Proposed Amendment No.1 to the Maynooth Local Area Plan 2013-2019

Response to Motions Received for Special Meeting of Maynooth Municipal District

Planning Department
Kildare County Council
9th October 2018

Indicative design strategy Fig: 5a

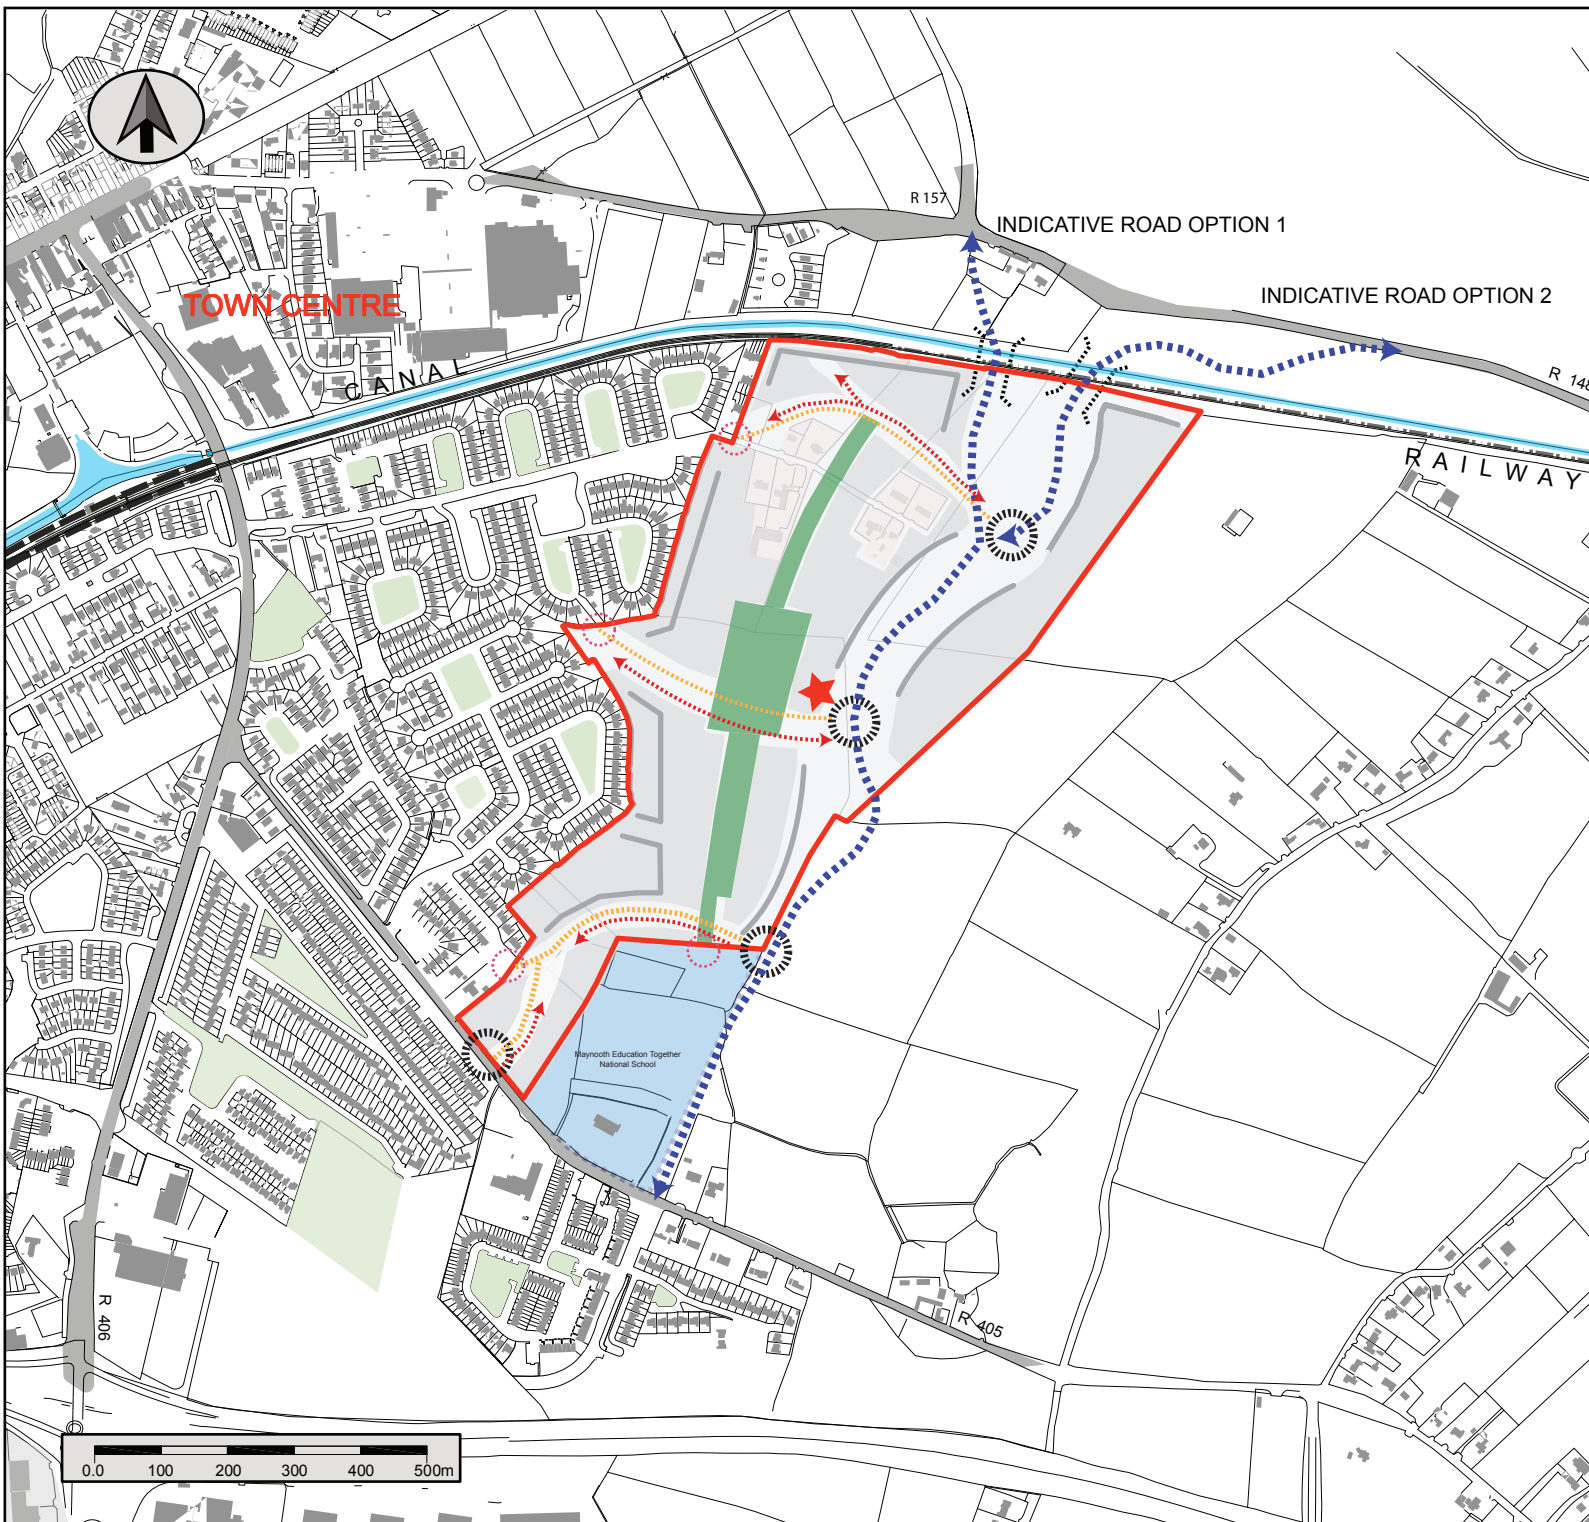
<p>15</p>	<p><u>Motion - Cllr. Teresa Murray</u></p> <p>That the proposed access/permeability links into Parklands Estate and Rockfield Estate to the west of Key Development Area Railpark are deleted from the map (indicative design strategy Fig:5a)</p>	<p>This matter is dealt with under Item no. 10</p>
<p>16</p>	<p><u>Motion - Cllr. Teresa Murray</u></p> <p>That access routes are included linking the Royal Canal Greenway, and the new developments within the town centre.</p>	<p>This matter is dealt with under Item no. 13.</p>
<p>17</p>	<p><u>Motion - Cllr. Teresa Murray</u></p> <p>When investigating pedestrian and cycle connectivity with proposed developments, that section 15.8.1 of the Kildare County Development Plan 2017-2023 "Permeability through existing housing estates shall be subject to local consultation" be adhered to.</p>	<p>This matter is dealt with under Item no. 10</p>
<p>18</p>	<p><u>Motion - Cllr. Tim Durkan</u></p> <p>That no pedestrian, cycle or vehicular links are established between Rockfield, Parklands or Rail Park with any of the proposed new estates to be developed on lands rezoned by this Local Area Plan review.</p>	<p>This matter is dealt with under Item no. 10</p>

Proposed Chief Executive's Change	
Access Links	
1.	Remove references to the 'Pedestrian/Cycle Access Points' from the Key Development Area on page 17 of the Proposed Amendment (Please refer to Appendix 1: Key Development Area for the existing and proposed Indicative Design Strategy).

Chief Executive's response to motions
Re. Access Links Tuesday 09/10/2018
